# Alexander Farm Solar Project

Kane County Zoning Board of Appeals January 3<sup>rd</sup>, 2024

from Petitioner

# Alleged Screening and Tree Issue

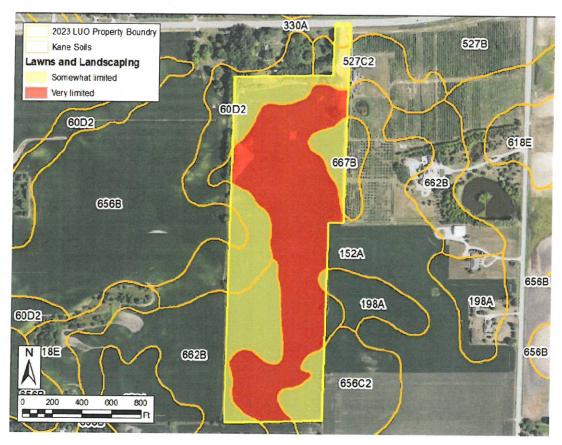
- Objectors have claimed that soil type isn't suitable for trees, based on this graphic
- Simplistic and incorrect analysis
- As shown on next slide, there are plenty of examples of trees in red areas
